CERTIFICATE OF APPROPRIATENESS

Proposal: Alteration – porch deck replacement

September 14, 2023 HPO File No. HP2023_0175

705 W Main St. First Montrose Commons

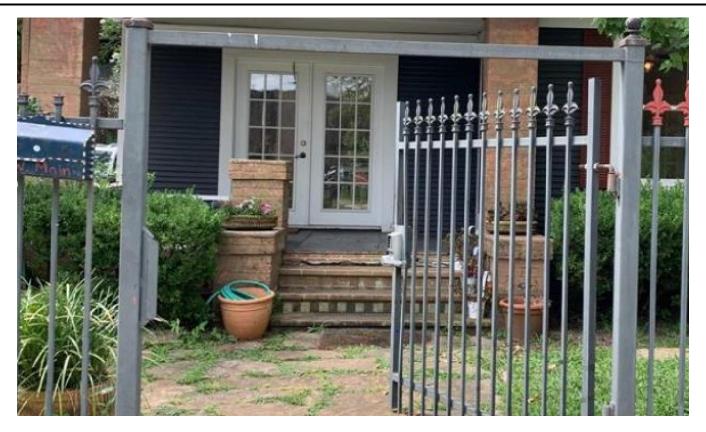
- Install 1x4 TG porch flooring over the existing porch flooring.
 - Porch boards to run perpendicular to the street.
 - Add one trim board to the mask the 2x6 board ends

Recommendation: Denial of COA and issuance of COR as applied for
